**RE: Lansdowne Street Goulburn Planning Proposal - Post-Gateway Referral**

I refer to Council's correspondence of 18 December 2019 referring the updated Planning Proposal (dated 15 November 2019) for Lansdowne Street, Goulburn, following the Gateway Determination of 16 December 2019. WaterNSW provided earlier comments on the Proposal on 7 November 2019 (our ref: D2019/121867).

**Map 1.** Lansdowne Street, Goulburn: Refined Drainage Mapping Overlay with Strategic Land and Water Capability Assessment.

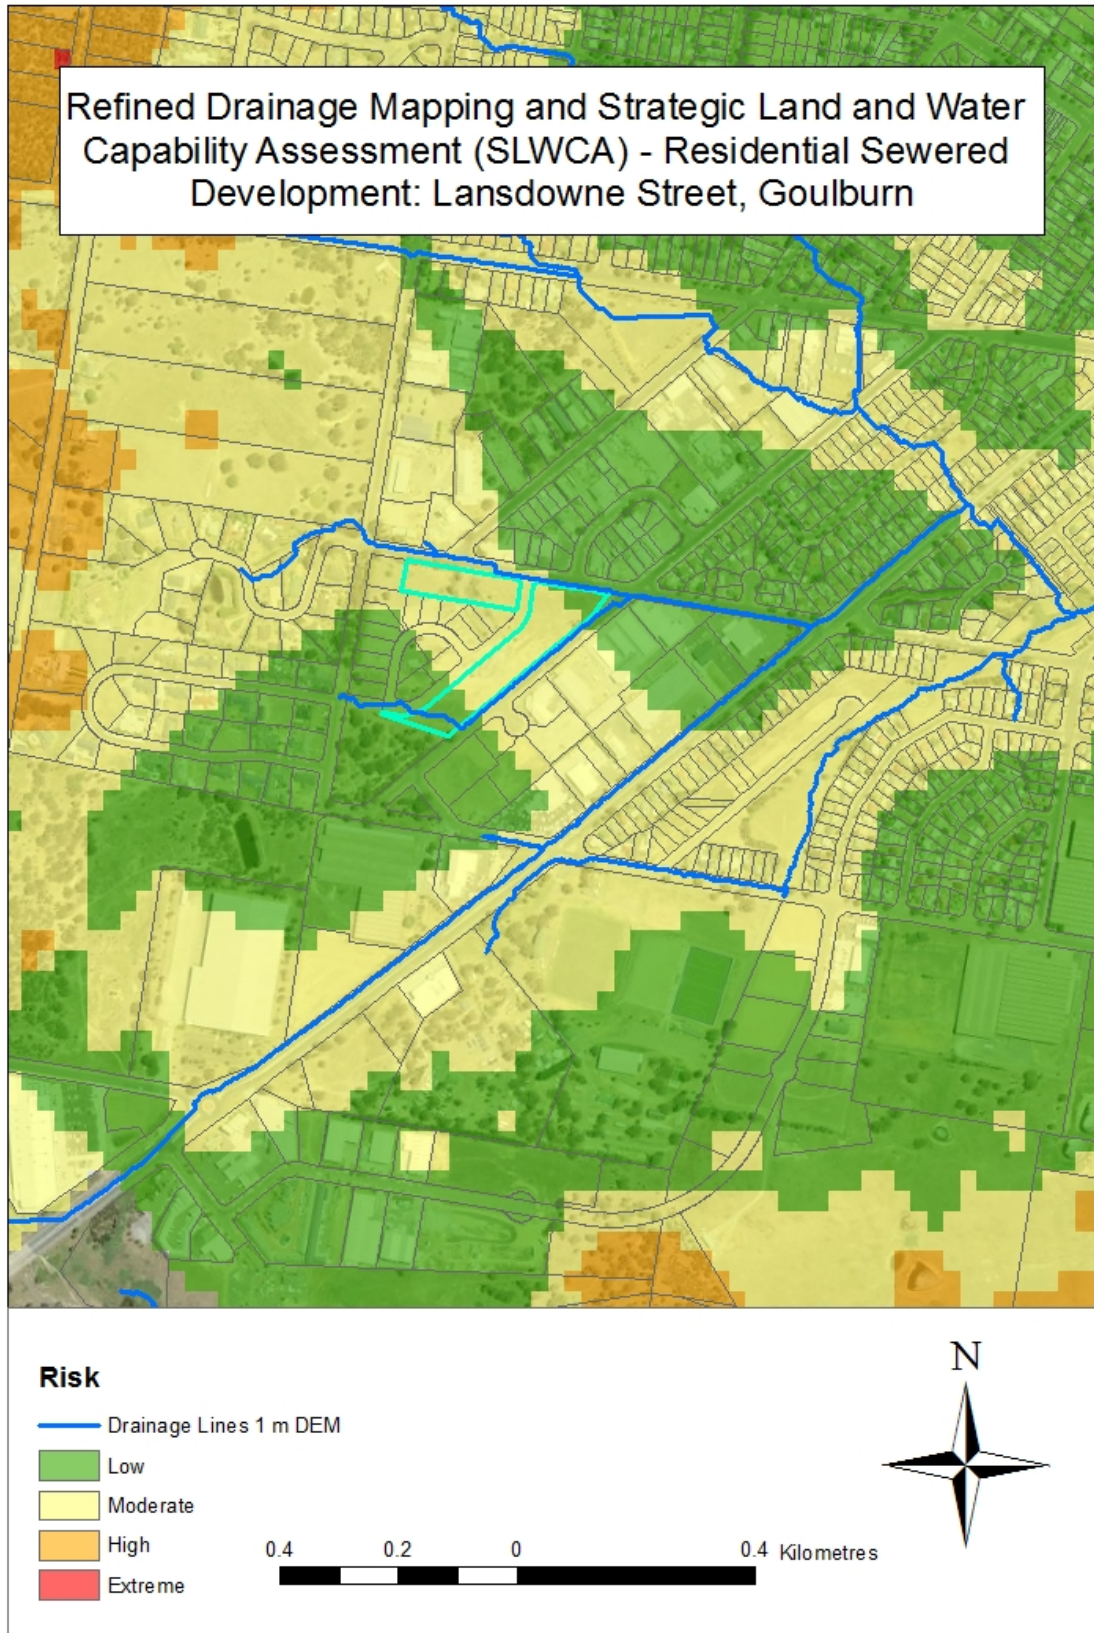
The report notes there are differences in watercourse mapping for the site, which are a minor issue for this Proposal. They have arisen due to different data and digital elevation models being used to determine topographic relief and the location of drainage features (p.22), rather than outdated information. WaterNSW has now run an ARC Hydro model on a 1m DEM with a 100m<sup>2</sup> catchment for the drainage lines. This identifies the drainage occurs along the northern and southern edge of the site, generally aligning with the road corridor and associated guttering.

Regardless of these differences, the site has been subject to past urban uses, predominantly operating as a drive-in theatre, with surface drainage being managed by kerb and guttering and a reticulated stormwater system. It is not a greenfield site and WaterNSW has no issues with proposed drainage management. As required by the SEPP, any future development of the site will need to have a neutral or beneficial effect on water quality.
